Comments on ECE/TRANS/WP.29/GRB/2017/5

France

ASEP-05-05

« Backfire » assessment

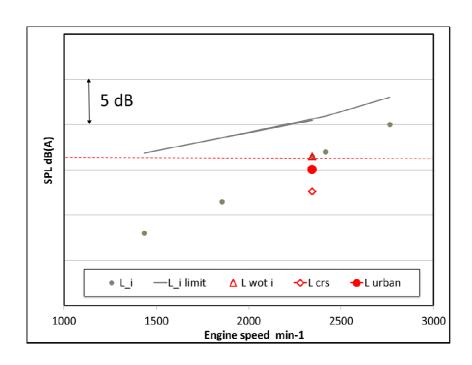
- From 5 to 10 dB reduction between BB' and BB'+20 m. Probably limited by background noise.
- From 5 to 10 dB reduction Lmax and Level at BB'.

Non compliant « backfire » level : From 1 to 15 dB above current level of non backfire vehicle + ASEP limits

« Backfire » assessment Software

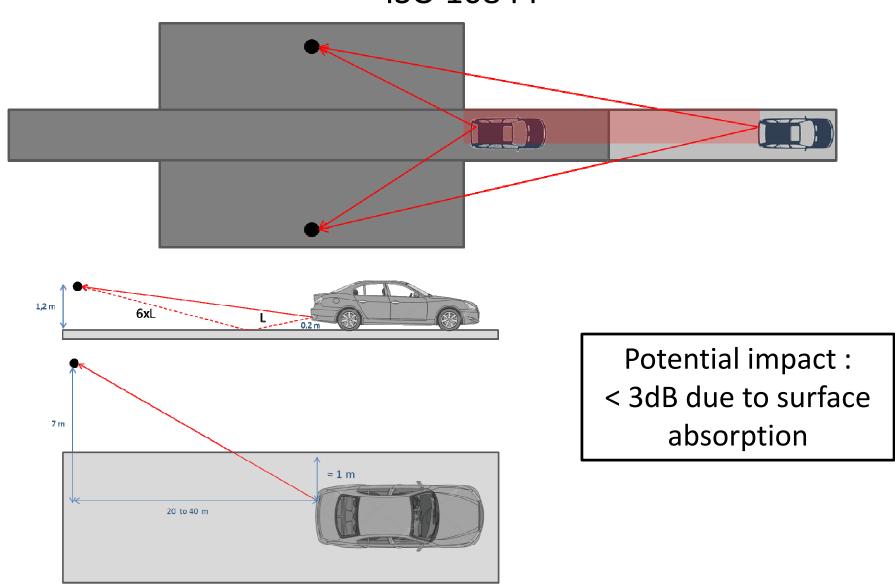
- No problem with usual sound level meter
- Should be possible for digital analyzer
- Accuracy required for pedal released position

« Backfire » assessment Indoor

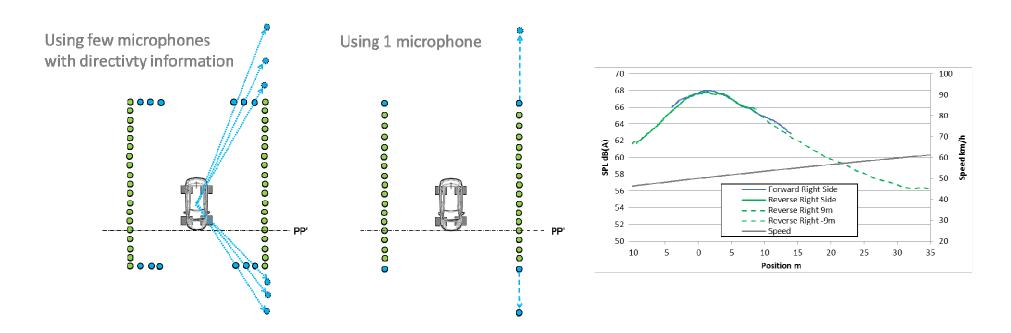
No room with more than 35 m are available

→ Backfire testing shall evaluated by extrapolation of the passby using representative(s) microphone(s)
